DEPARTMENT OF ECOLOGY

MEMORANDUM
December 30, 1980

Subject: Port Orchard Sewage Treatment Plant Class II Inspection

Figure 1. Port Orchard STP.

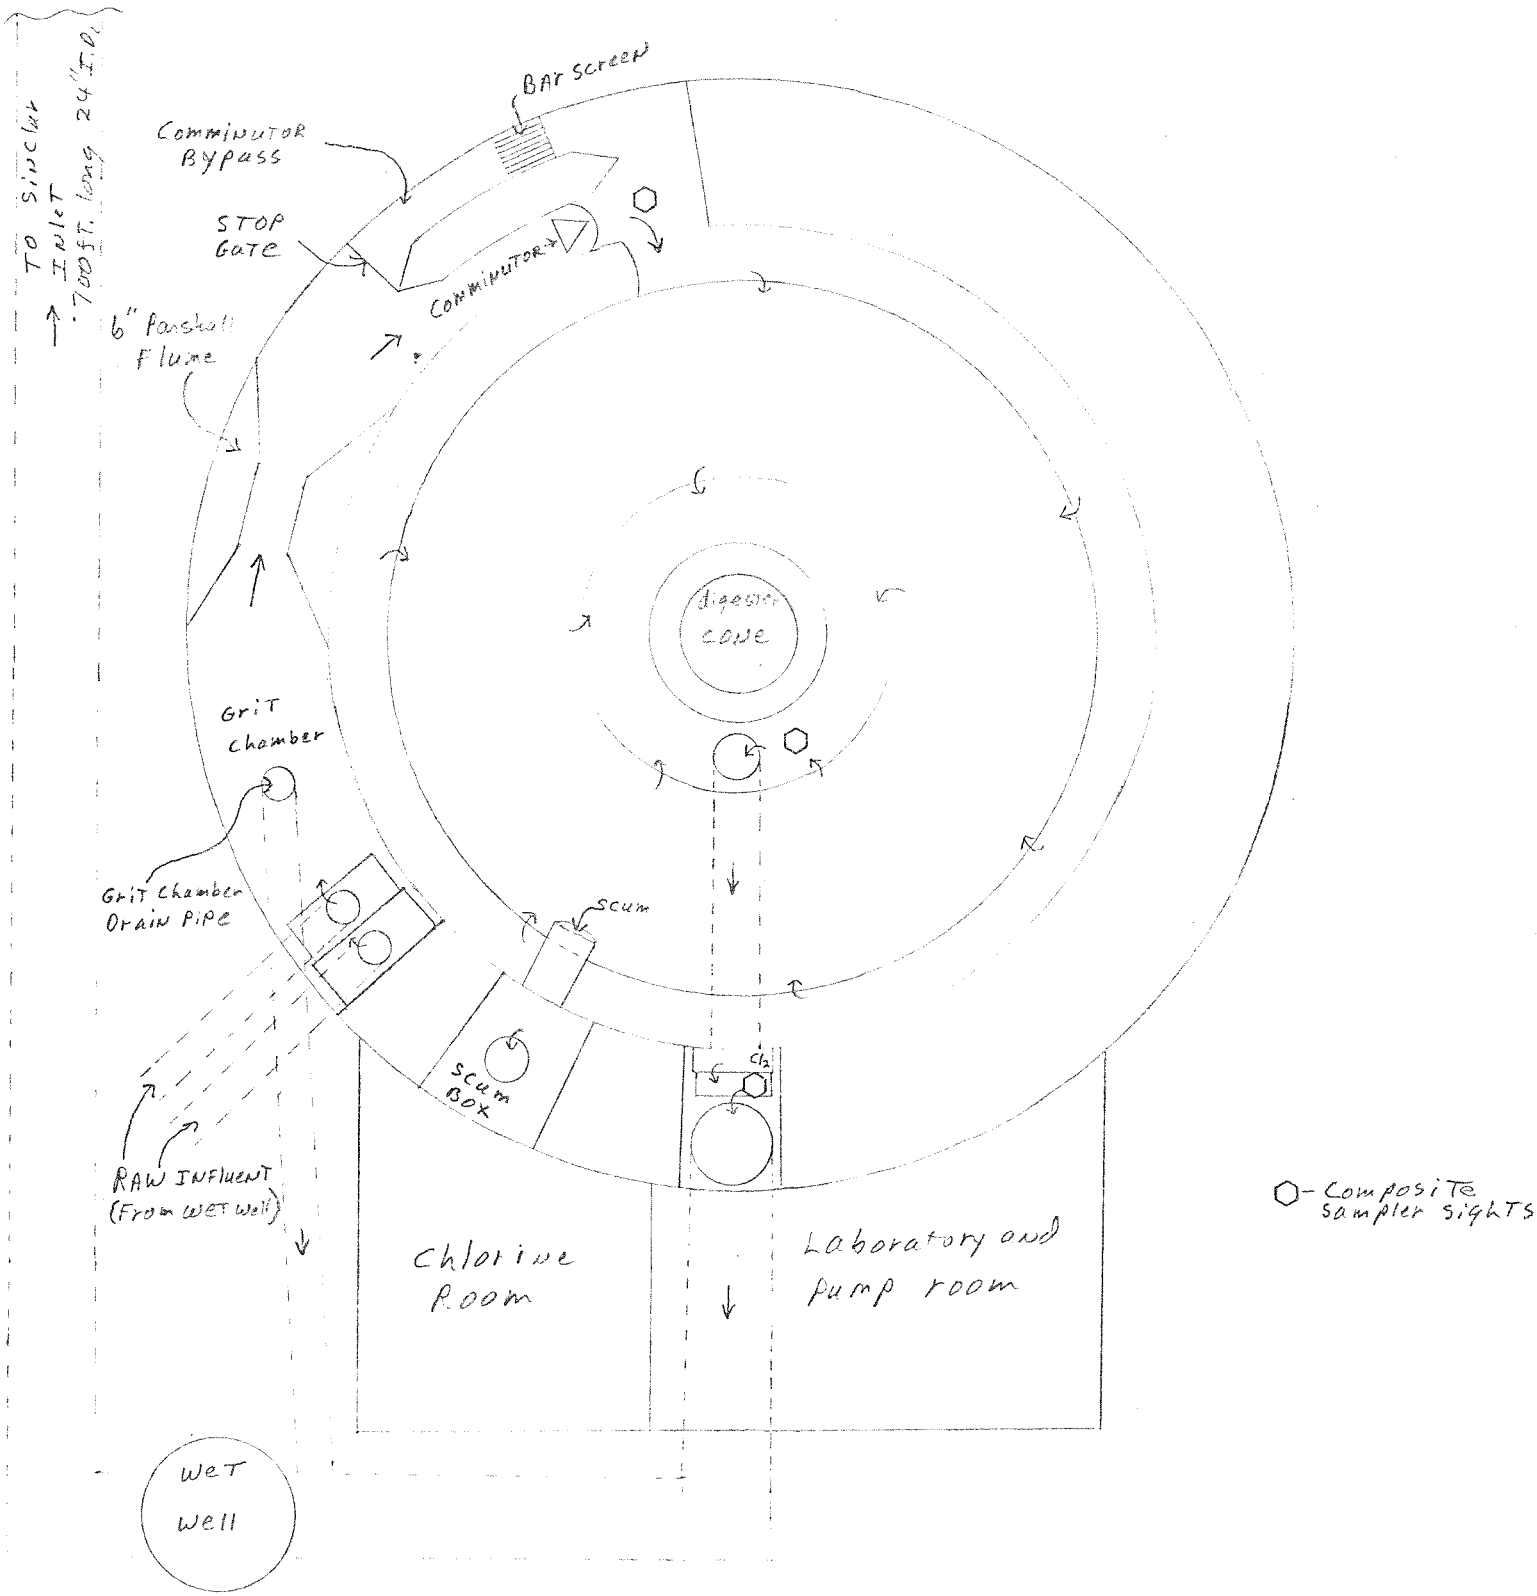
drained. Because sludge solids have been observed floating to the clarifier surface, it is highly probable that the cone has holes in it.

Short of draining and cleaning the clarifier, which would require a bypass, we are not aware of any way of solving the sludge pumping problem. Until the sludge problem is solved, any appreciable improvement in effluent quality is unlikely.

Figure 2.

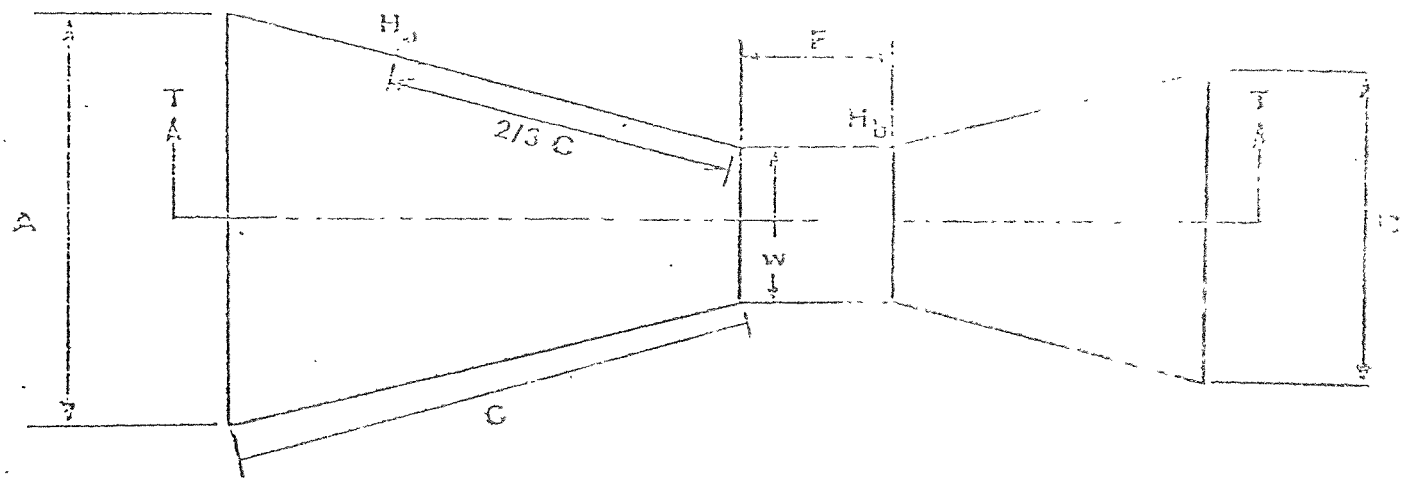
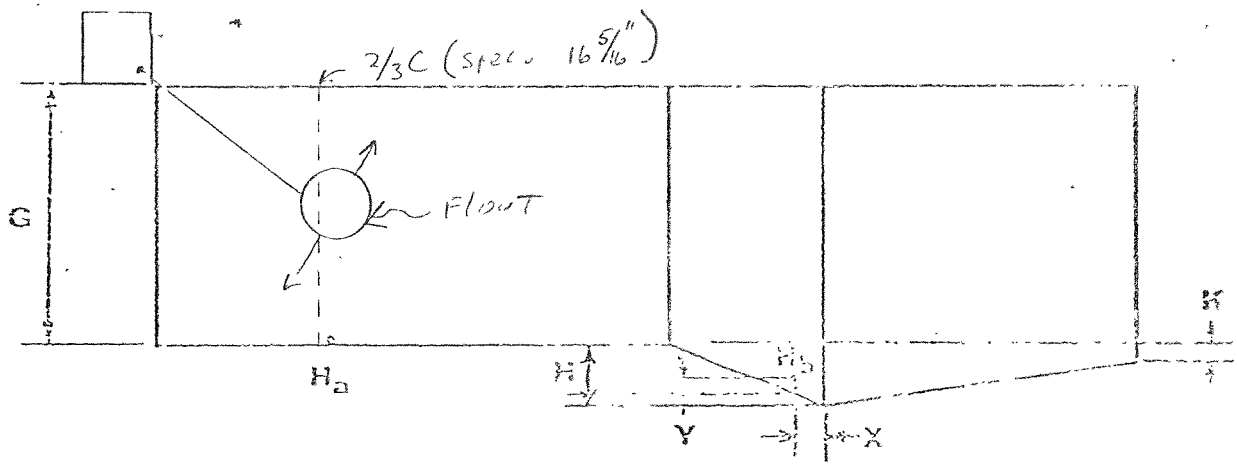
The Parshall flume was measured and determined to be within limits specified for a six-inch throat, except for the point at which the head is measured (Figure 2). Head is measured using a float which swings in an arc as the flow fluctuates. This results in a 2/3 C value ranging from 21 to 14-1/2 inches, causing an undetermined amount of error in flow measurement.

5. The flow monitoring apparatus should be calibrated by a qualified techincian as soon as possible.

Figure 3. Manning Dipper 24-hour strip chart.

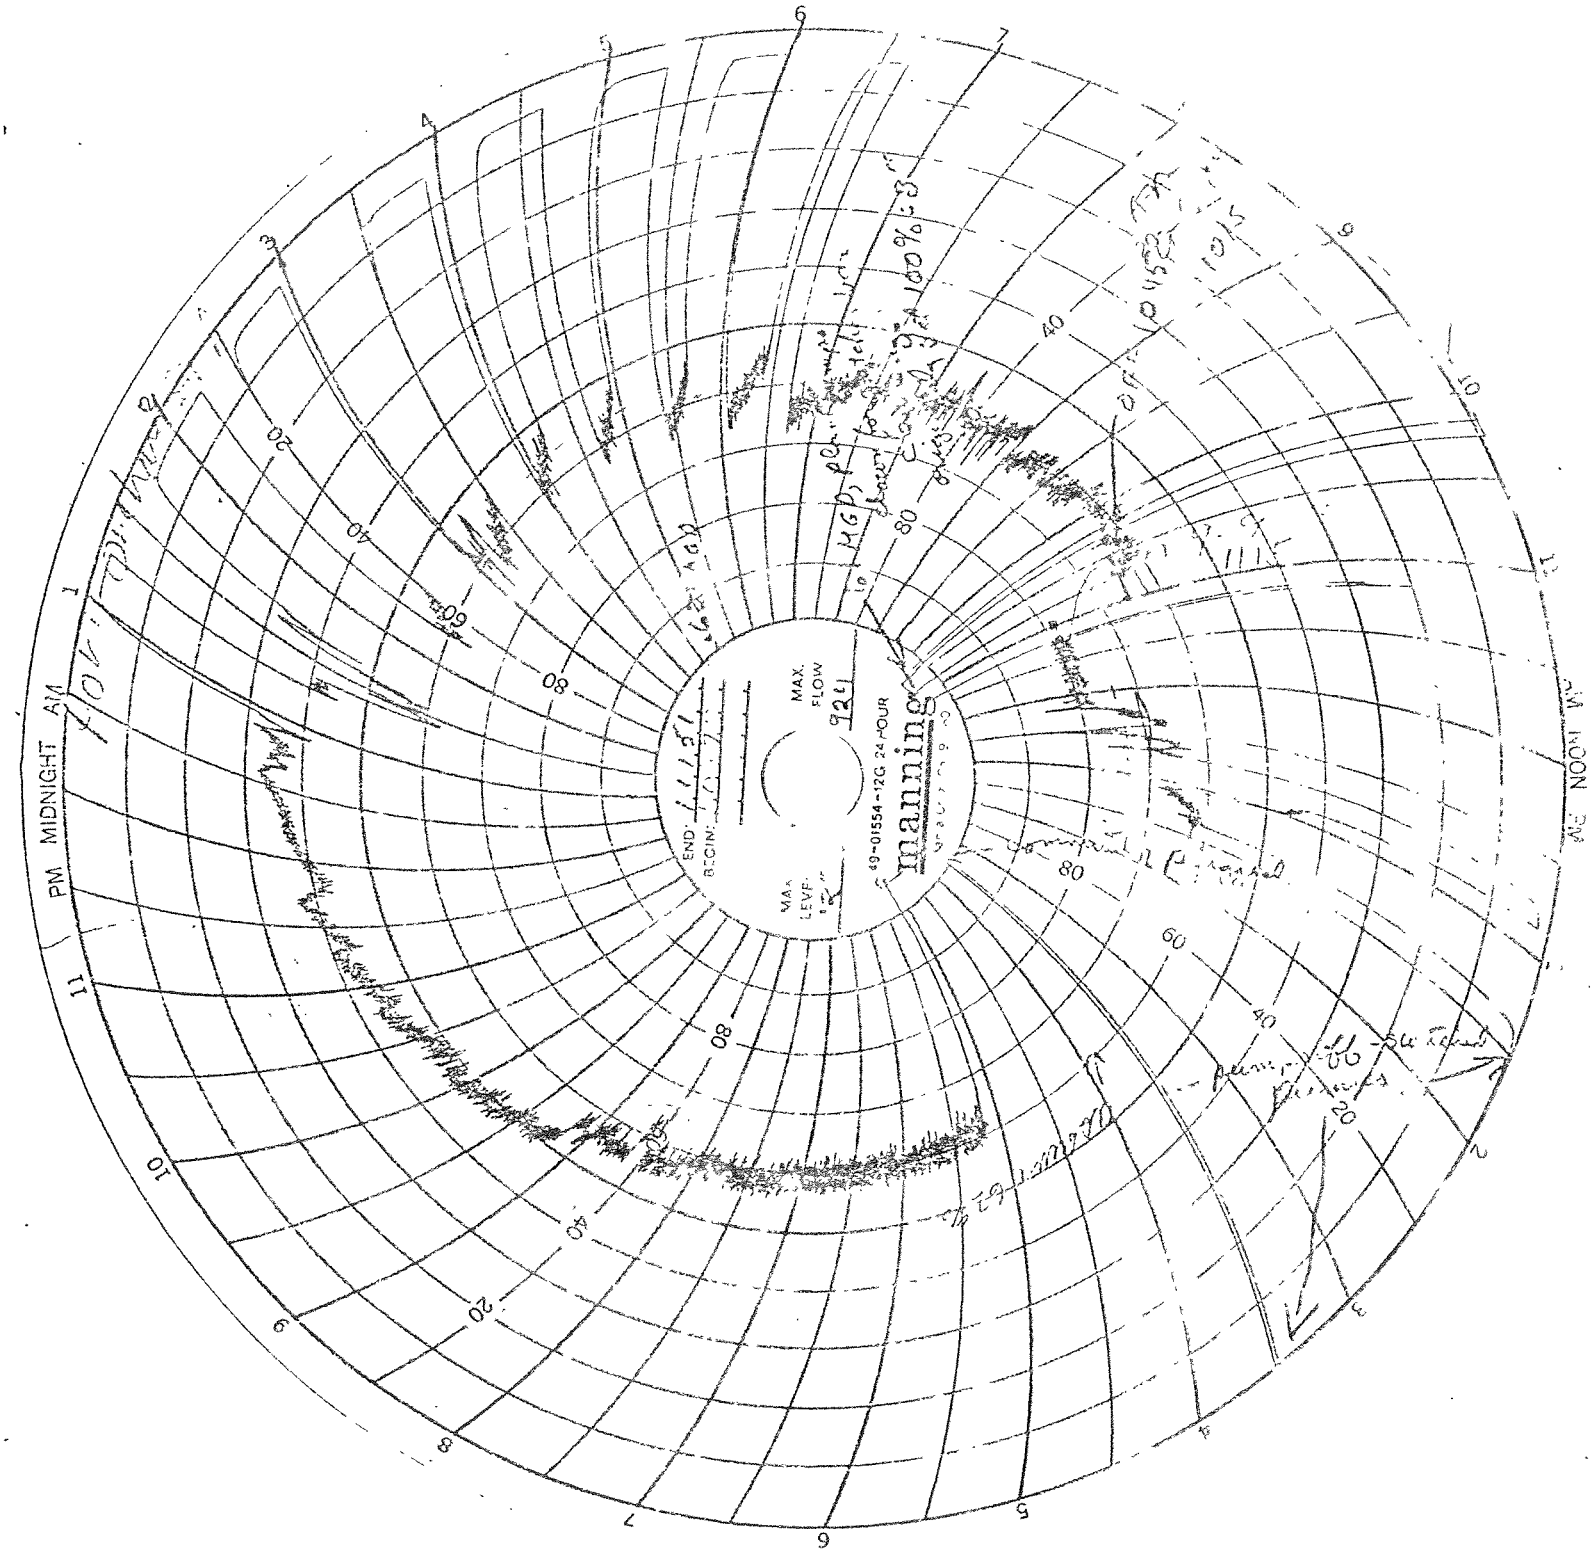
A Manning dipper was installed on the Parshall flume on September 9, 1980 (Figure 3). Initially, the dipper was set to read 100 percent at eight inches of head, or a maximum flow of 0.850 million gallons per day (MGD). The influent pumps were down for grit chamber cleaning and the influent was being stored in a wet well when the dipper was installed. Upon reactivating the pumps, the flow increased to 1.10 MGD which exceeded the dipper capacity. At 1115, the dipper was reinstalled with a maximum flow of 1.33 MGD. An additional problem occurred when the influent pumps and comminutor were turned off from 1320 to 1530 in order to repair a pump. The pumps were restarted but the comminutor was inadvertently left off causing the influent to overflow the flume, resulting in erroneous dipper and STP totalizer readings. In order to acquire a 24-hour average flow, hourly average flows were calculated from the strip chart and then averaged on a 24-hour basis (Table 1).

Figure 5. Detention Time in Outfall Line

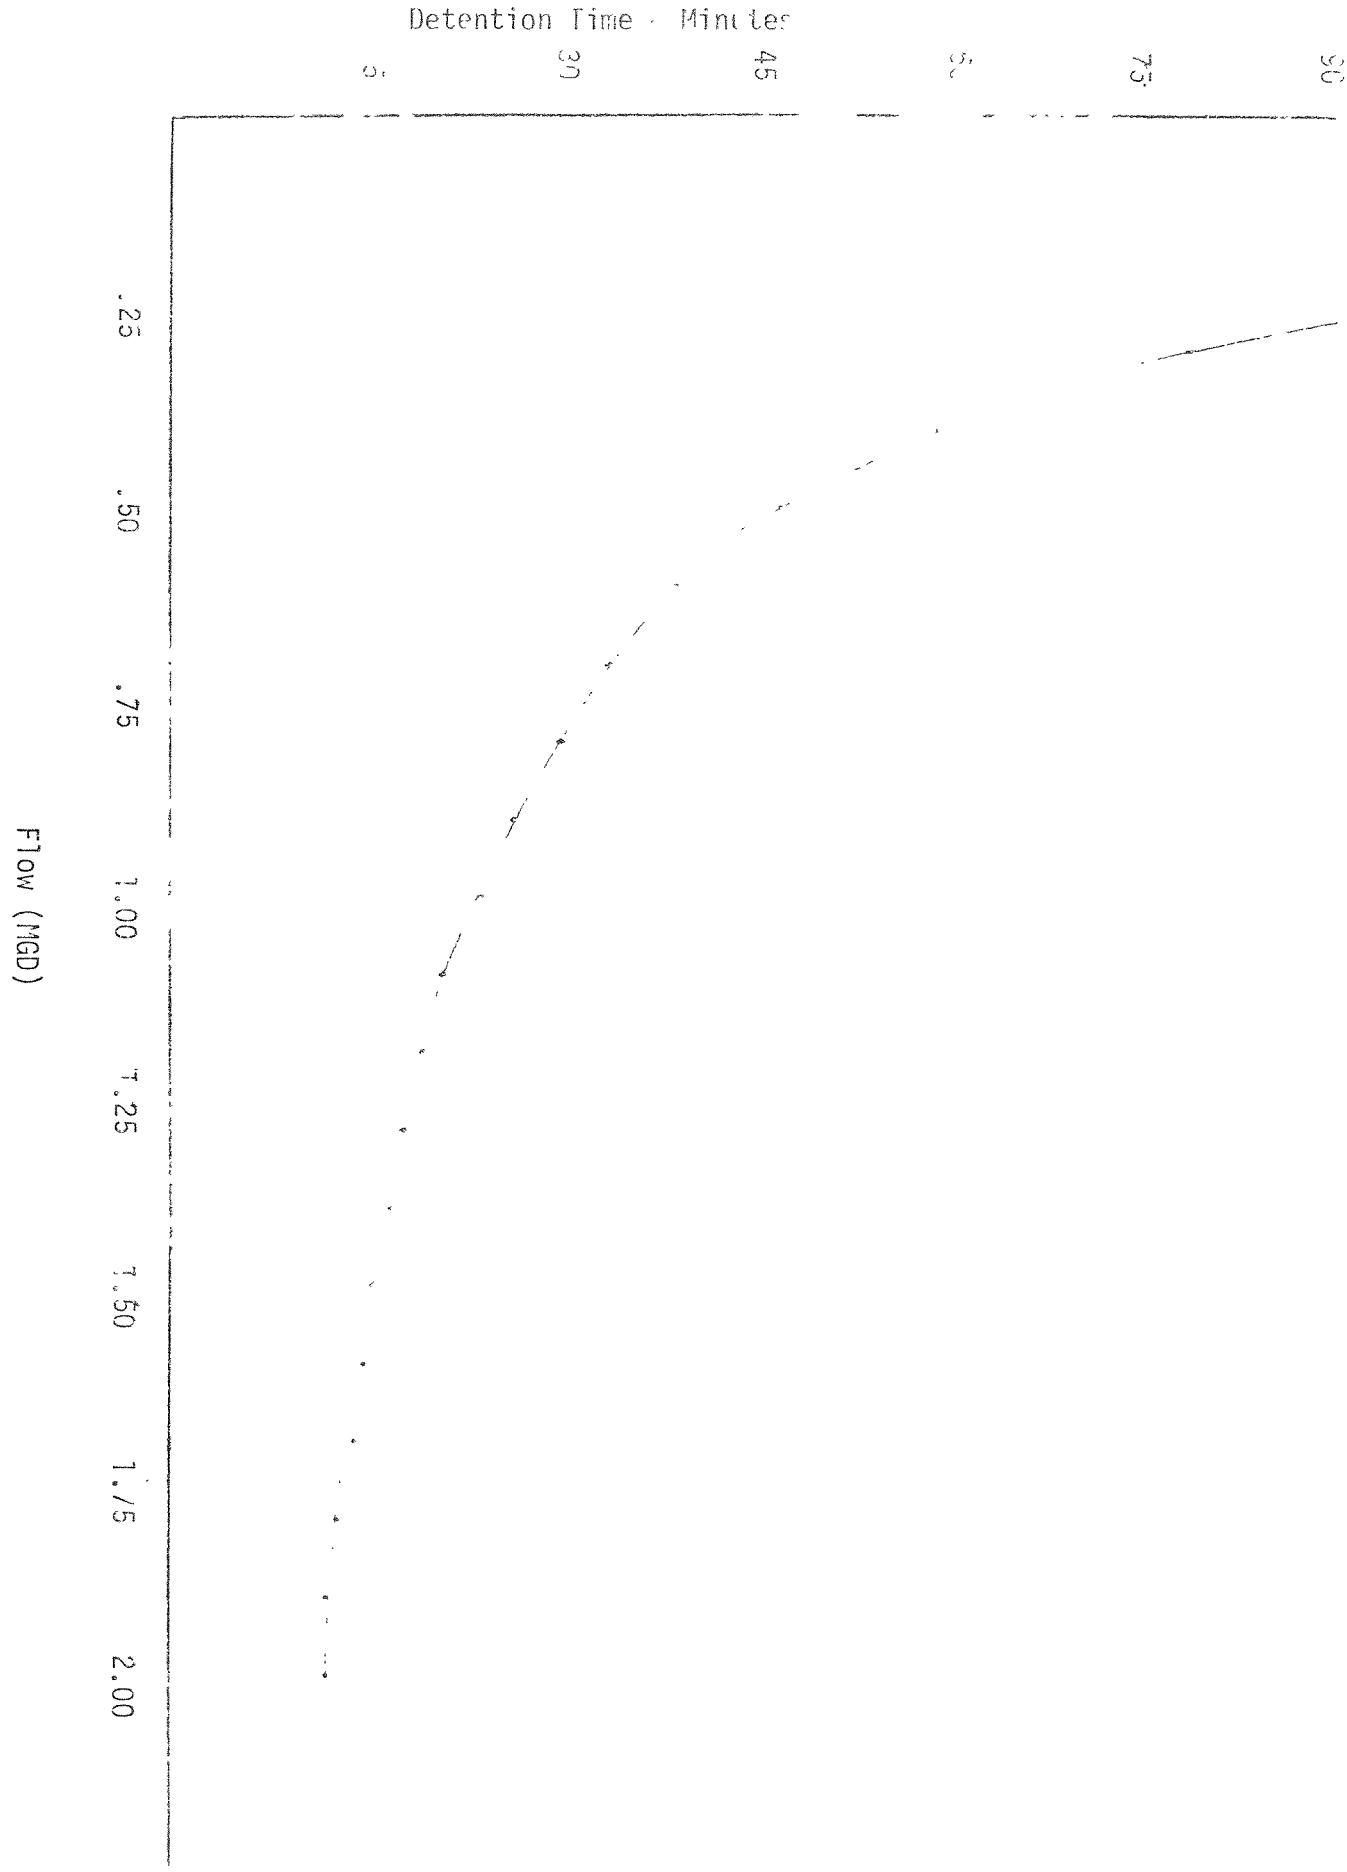
Table 5 is a mathematically produced graph of flow (MGD) versus detention time in the outfall pipe (minutes). It is recommended that the STP operator take detention time in the outfall pipe into account when dechlorinating the fecal coliform sample. The desired

procedure for fecal coliform sampling and dechlorination is to take a sample in a sterile bottle, wait the allotted detention time period, then pour the sample into a sterile bottle containing a sufficient amount of sodium thiosulfate (1 ml per 4 oz. of sample). The sample should then be kept refrigerated or iced until analyzed.

1. Use Figure 5 to determine detention time in the outfall line. Fecal coliform sample dechlorination and total chlorine residual should not be done until the detention time has passed. We are primarily interested in the quantity of the effluent when it reaches Sinclair Inlet. Accounting for detention time in the outfall is more representative of the true condition.
